DEPARTMENT OF TRANSPORTATION**National Highway Traffic Safety Administration****49 CFR Part 572****[Docket No. NHTSA–2009–0002]****RIN 2127–AK26****Anthropomorphic Test Devices; SID–IIs Side Impact Crash Test Dummy; 5th Percentile Adult Female**

ACTION: Final rule, response to petitions for reconsideration, technical amendment.

SUMMARY: This final rule responds to petitions for reconsideration of a December 14, 2006 final rule establishing a new small adult female side impact crash test dummy, called the “SID–IIs” test dummy. The petitions were submitted by the Alliance of Automobile Manufacturers, First Technology Safety Systems, and Denton ATD. In response to the petitions, among other things today’s final rule modifies the iliac performance criteria to allow a new material formulation and design to be used for the iliac wing of the dummy’s pelvis, defines a time period in which accelerations are measured in the thorax with arm and pelvis acetabulum tests, slightly modifies some of the test procedures used in the qualification tests (*e.g.*, by slightly lowering the impact speed of the impactor in two tests and by increasing the recovery time for the pelvis-iliac and pelvis-ace

Figure 1: Alignment of iliac wing, backer plate, and load cell/replacement¹⁶

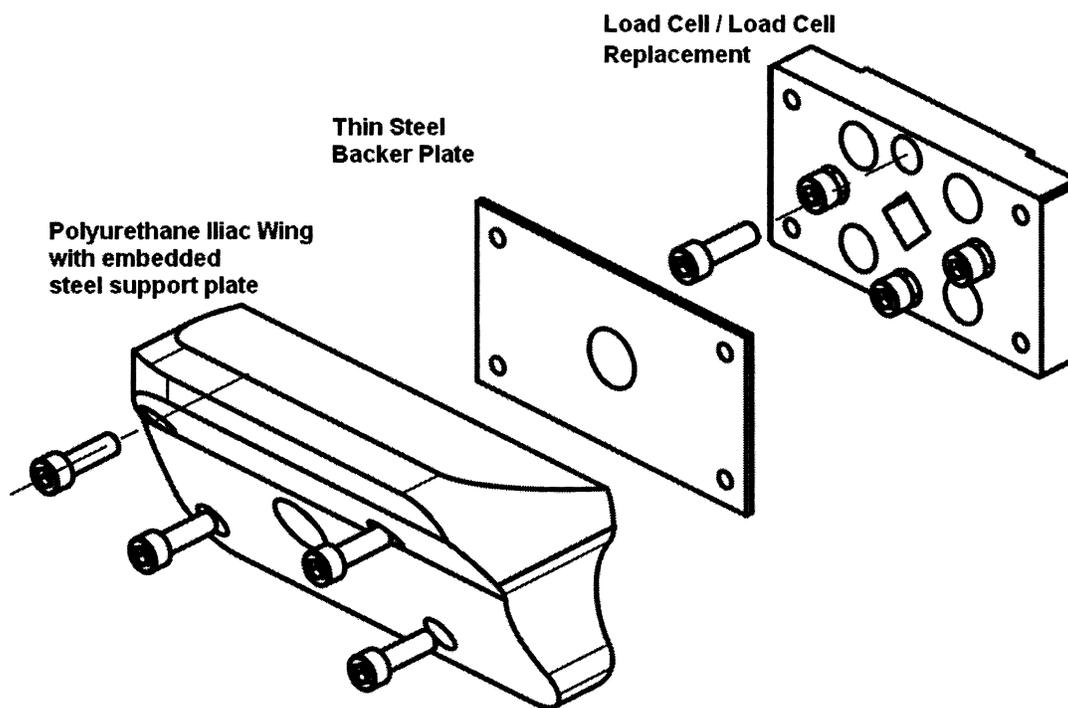
In response to the final rule, FTSS noted that, in general, the iliac wing specified in the final rule has the

propensity to cause a load path short due to its design. According to FTSS, the original iliac wing design resulted in 1/8-inch polyurethane material being sandwiched between the embedded iliac wing support plate and the iliac load cell. It found that the amount of loading force the iliac is able to accurately measure can vary depending upon how much torque the iliac mounting screws are under, how much the polyurethane material creeps over time, and how much the iliac maintains its original shape.

FTSS stated that it has designed a new iliac substructure (support plate) that has a positive bearing surface contact between the iliac wing and the load cell to create a rigid mounting surface between the iliac wing and load cell.¹⁷ Essentially, the 1/8-inch thick polyurethane material around the mounting screw holes was replaced with 1/8-inch thick steel “standoffs” that extend from the embedded plate to the edge of the wing so that the mounting screws would draw the iliac wing to the load cell through a metal contact instead of through polyurethane. According to FTSS, this design eliminated the

potential for load path shorting since standard fastener torque values can now be specified for the iliac wing mounting hardware without losing the torque over time, and it also eliminated the material creep found in the original iliac design. FTSS recommended that NHTSA evaluate this new design and include it in the drawing package in place of the original.

artificially low measurements.” It stated, however, that while the use of the thin steel backer plate specified in the final rule (as shown in Figure 1) will reduce the likelihood of off-loading the load cell, it will not reduce deformation of the polyurethane iliac wing. It suggested that a more robust solution would be to use a rigid steel plate with standoffs that are embedded in the polyurethane iliac wing during manufacturing. The Alliance stated that “this stronger plate with standoffs eliminates the possibility of off-axis loading.”

plate between the wing and load cell, as specified by the final rule (Table 2). VRTC found that qualification test results from these two iliac configurations were very similar. The average response from wings without a backer plate was always lower than that from wings with a backer plate as seen in Table 2, but was also always less than a 2.5% reduction from the response with a plate.²⁰ Thus, the influence of the backer plate appears to be negligible. However, the plate can act to prevent load path shorting through wing contact with the center of the load cell. Although there were no instances of load path shorting during qualification tests without a plate, two quasi-static tests without a backer plate were conducted on both the softest and stiffest M3 iliac wings with standoffs. In this set of tests, the softest iliac wing made contact with the center of the load cell at a load of about 3,700 N (831.8 lb). To prevent this from happening, we have decided to retain use of the thin steel backer plate between the iliac wing and iliac load cell.

Figure 2: Examples of pelvis-acetabulum, pelvis Y acceleration response traces

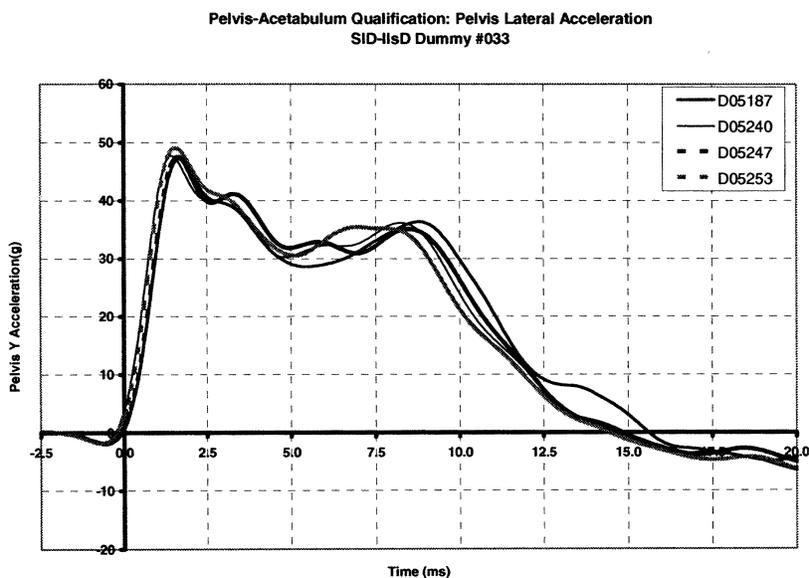
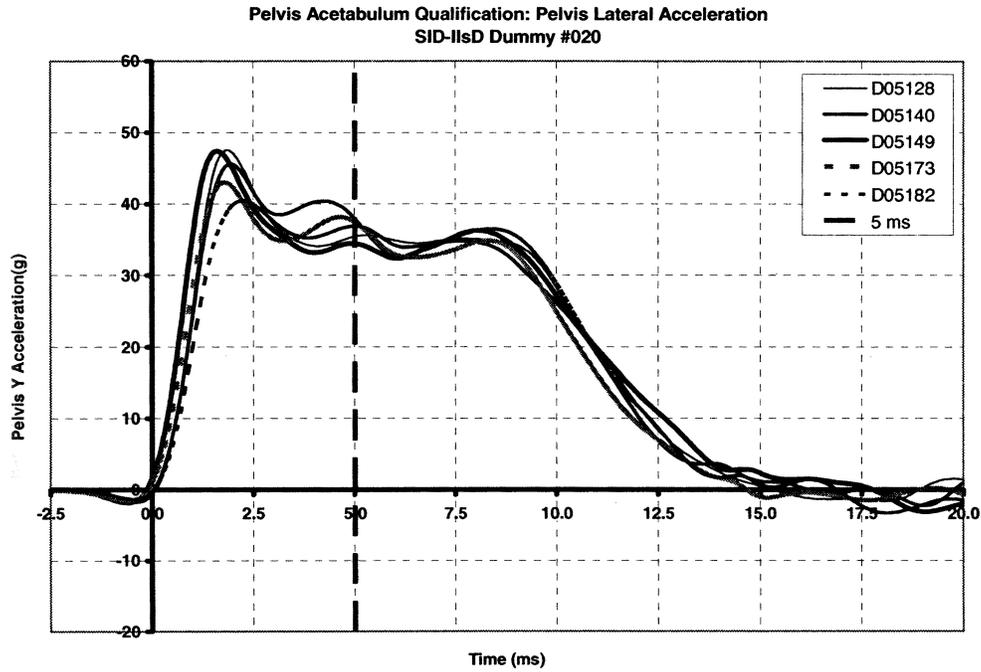
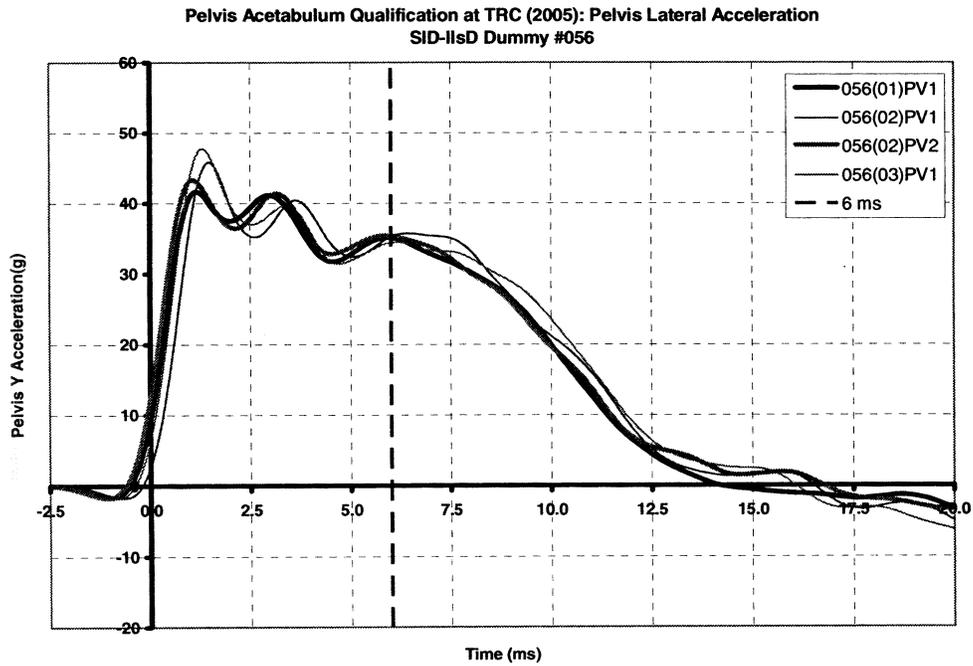
Denton/SAE DTES recommended removing the pelvis lateral acceleration requirement from the test due to what was believed to be a large variability of response. An attachment to the petitioner's submission stated that a member of the SAE DTES presented pelvis lateral acceleration data from three different laboratories where the data looked distinctly different. It was noted in the attachment that the shape of the pelvis lateral acceleration peak varied widely, even with a single dummy in one lab. The DTES discussed possible reasons for the high variability of the first peak, but were not able to discern a definite explanation for this behavior. Although they agreed that variability was reduced when the acceleration peak was taken after 5 ms, they did not think that the measurement was necessary for qualification of the dummy and therefore recommended that the peak pelvis lateral acceleration be dropped. Alternatively (as seen in the next section), if the pelvis lateral acceleration parameter were not dropped, Denton/SAE DTES recommended to take the peak after 5 ms to eliminate the variable first peak.

It was not clear from the data that 5 ms was the most appropriate time to begin measuring a peak value. For each of these 46 traces, the peak values after 5 ms, 6 ms and 7 ms were obtained in order to determine how much time after probe impact should be disregarded to prevent the first peak from being measured. It was found that in five of the 46 tests, the maximum value after 5 ms was higher than that after 6 or 7 ms, because the value of the decreasing “first peak” response at 5 ms was higher than the main dummy response peak value. Four of these 5 instances occurred in Dummy S/N 20, and are seen in Figure 3 below. These cases led the agency to determine that the peak should be taken after 6 ms. However, in

two tests, the peak of the main dummy response occurred just before 6 ms (see Figure 4), causing the peak after 6 ms to be slightly less than the actual peak. This occurrence was rare, though, and only resulted in an error of approximately 0.1 g for both tests. As a result of this evaluation, this final rule specifies that the peak pelvis lateral acceleration be taken after 6 ms.

Figure 5: Peak shoulder deflections generated at probe impact velocities of 4.2 – 4.5 m/s

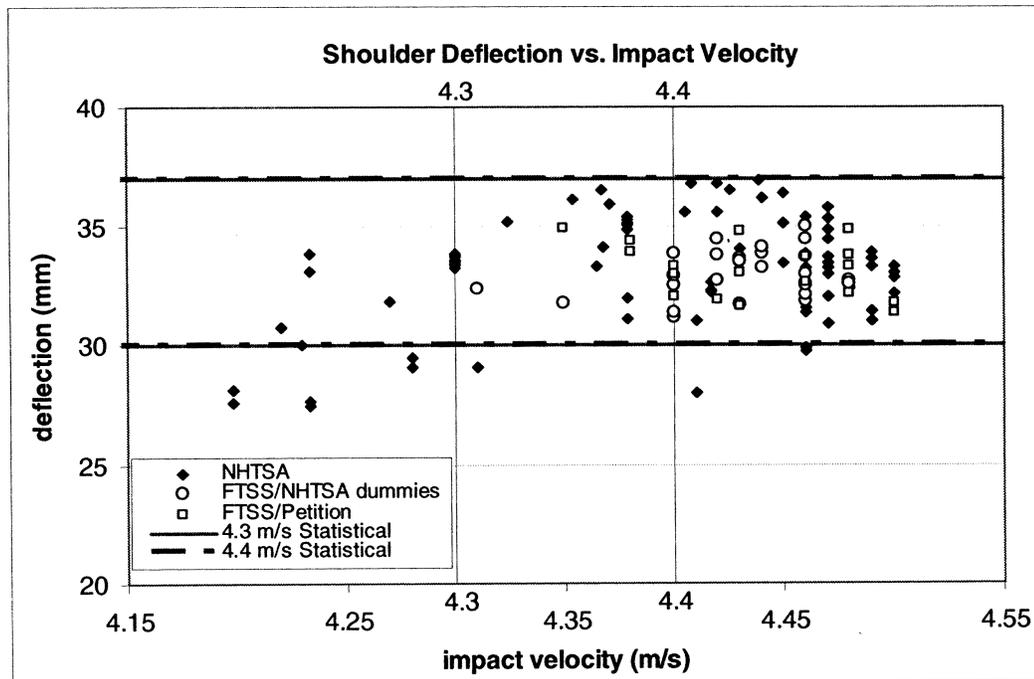
Figure 5 shows the peak shoulder deflection responses with respect to the impact speed of the pendulum. It is observed that the peak deflections are noticeably lower at impact speeds of approximately 4.2 m/s. Because of this observation, the qualification performance corridors have been formed with the mindset that the statistical corridor (which is centered at the mean

of the data set) may have to be adjusted to accommodate low deflections at the low impact velocities, since the mean of the 4.2–4.4 m/s data set may be slightly high due to the majority of tests being conducted between 4.3–4.4 m/s. The revised corridors are discussed in “Analysis and Development of SID–IIIsD Qualification Specifications in Response to Petitions for Reconsideration (July 1,

2008),”³¹ and in section XI.a of this preamble. We believe that by adjusting the performance corridor to reflect deflection responses at lower impact velocities, the new performance corridor will satisfactorily represent dummy responses over the full range of the revised specified impact velocities.

**FIGURE V4-A
SHOULDER IMPACT**

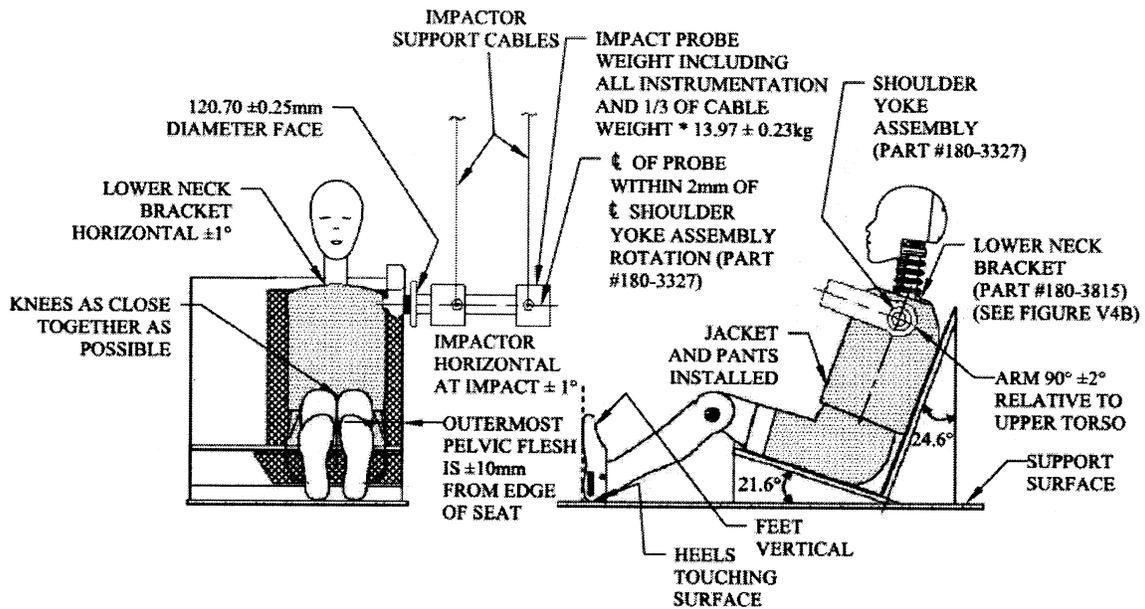
■ 13. Figures V4-A, V9-A and V9-B in "Appendix A to Subpart V of Part 572-Figures" are revised to read as follows:

**FIGURE V9-A
ILIAC IMPACT**

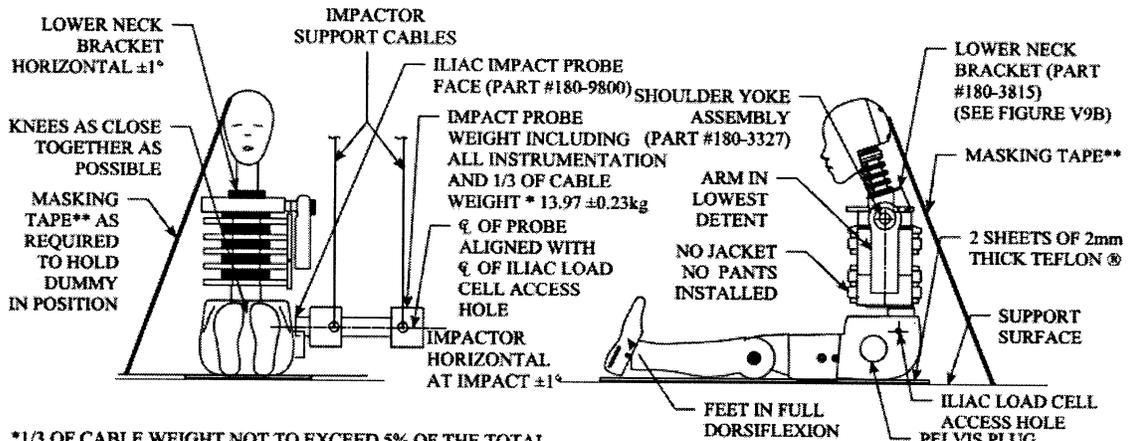
(5) The midsagittal plane of the dummy is vertical, and superior surface of the lower half neck assembly load cell replacement (180-3815) in the lateral direction is within ±1 degree relative to the horizontal as shown in Figure V9-A.

**FIGURE V9-B
ILIAC IMPACT
(NON-IMPACT SIDE VIEW)**

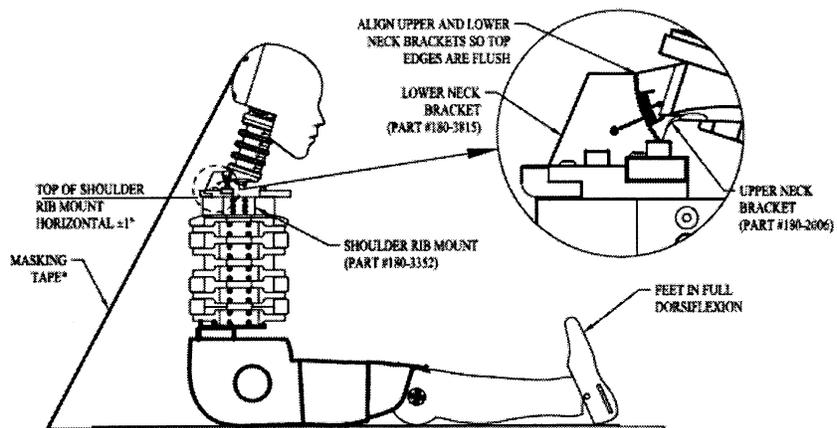
(6) While maintaining the dummy's position as specified in paragraphs (b)(3), (4) and (5) of this section, the top of the shoulder rib mount (180-3352) orientation in the fore-and-aft direction is within ±1.0 degree relative to horizontal as shown in Figure V9-B in Appendix A to this subpart.
